From: Jill Bastow
Sent: 06 September 2017 11:29
To: Planning
Subject: Fwd: NYM/2017/0433/FL - Midstream Cottage, Thornton le Dale
Attachments: 04 F Proposed Floor Plans and Elevations.pdf

Project: Extension and refurbishment
 Midstream Cottage, Thornton le Dale
 for: Mr. & Mrs. D. Shaw

Drawing title: Proposed Floor Plans and Elevations

WG477 - 04 F

SKETCH PERSPECTIVE

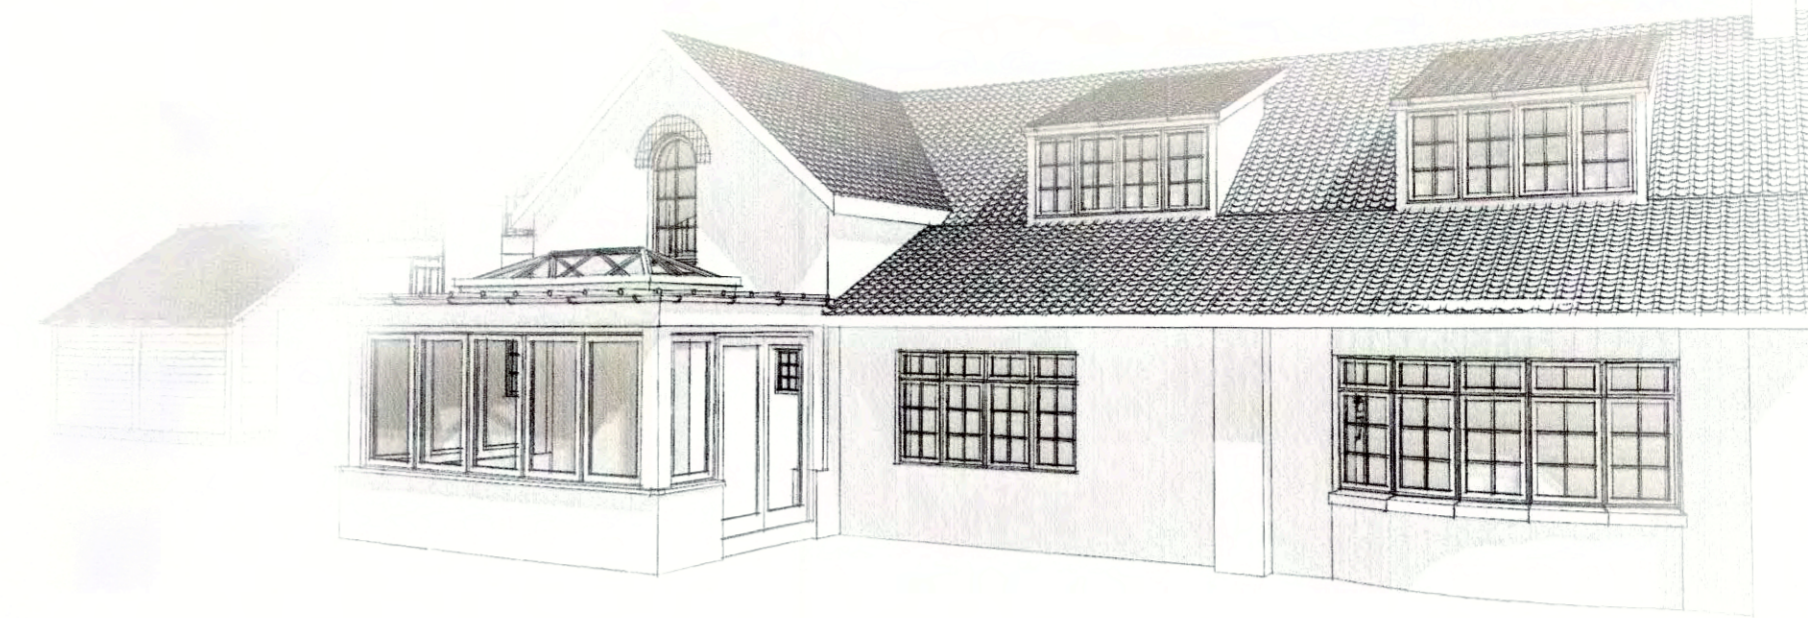
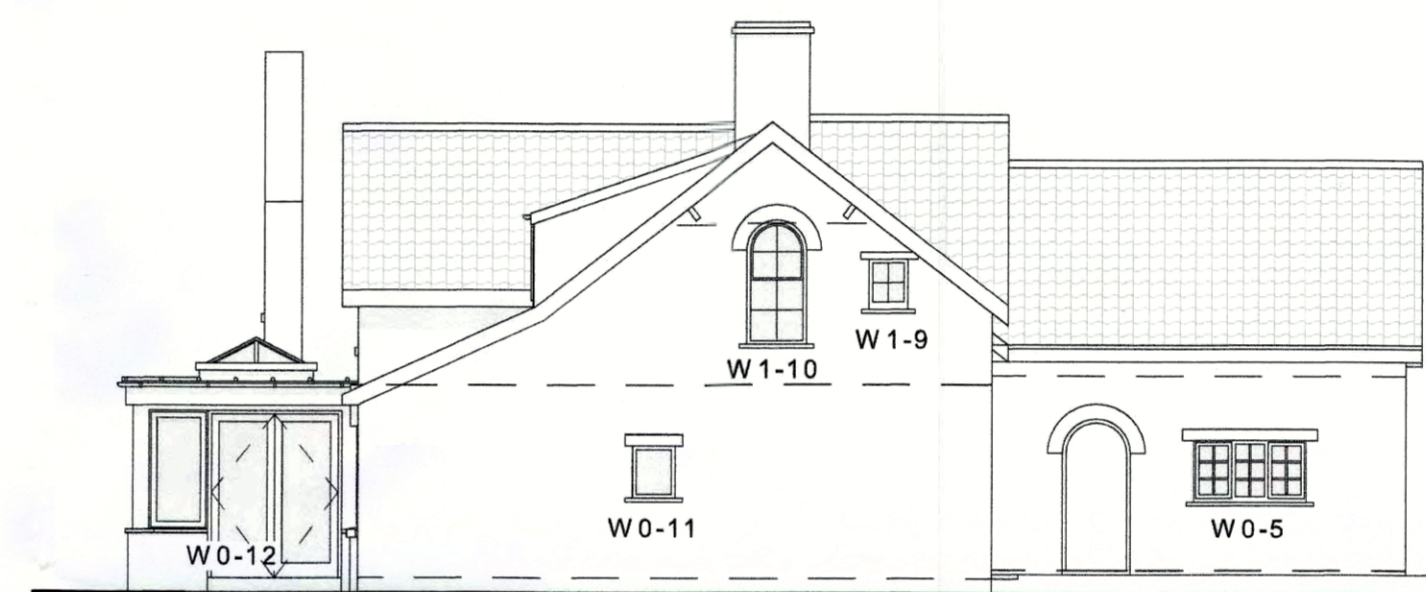
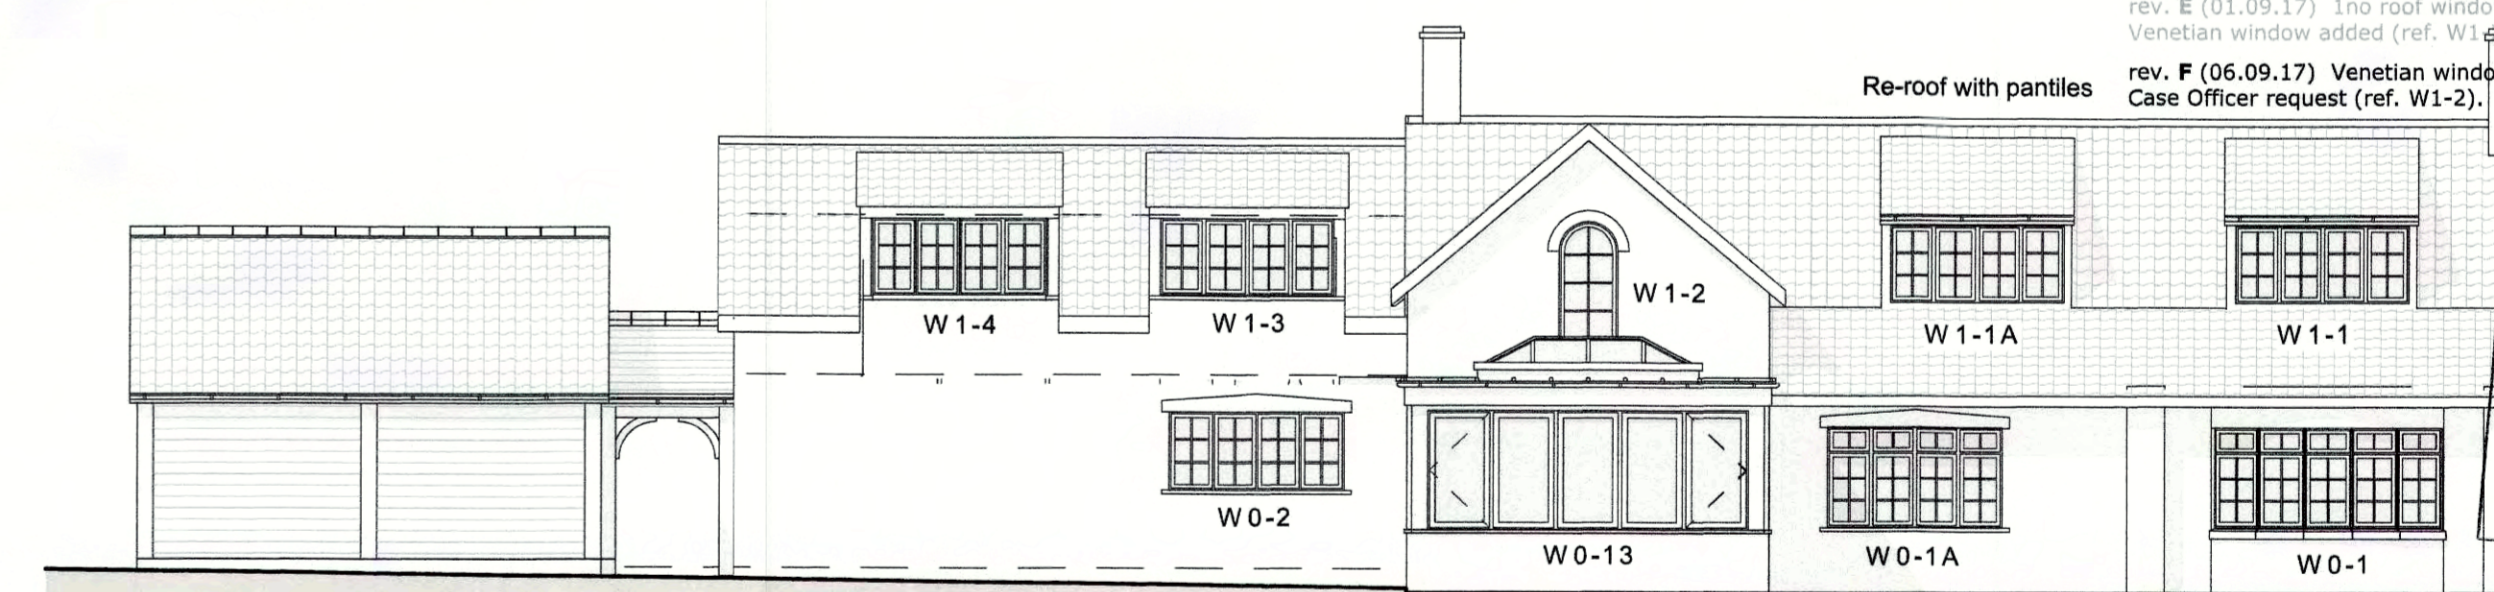
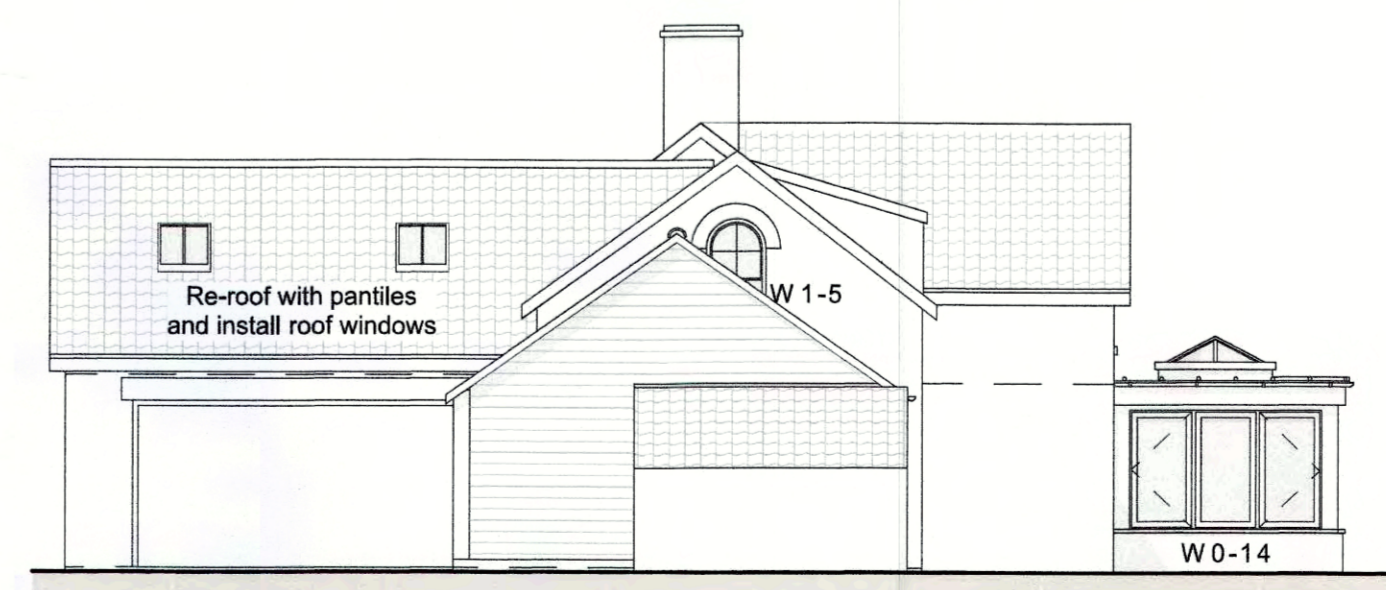
I've revised the proposal drawing (attached) to simply revert to an arched head window to the Bedroom in place of the Venetian. This is the original option we applied for and better compliments the gable. I trust this is acceptable.

- rev. A Design options prepared in response to pre-application enquiry comments.
- rev. B (23.05.17) Revised to Client preferred scheme.
- rev. C (05.06.17) Study external door removed.
- rev. D (02.08.17) Window references added.
- rev. E (01.09.17) No roof window omitted from existing Garage. Venetian window added (ref. W1-1).
- rev. F (06.09.17) Venetian window reverted to arched head only at Case Officer request (ref. W1-2).
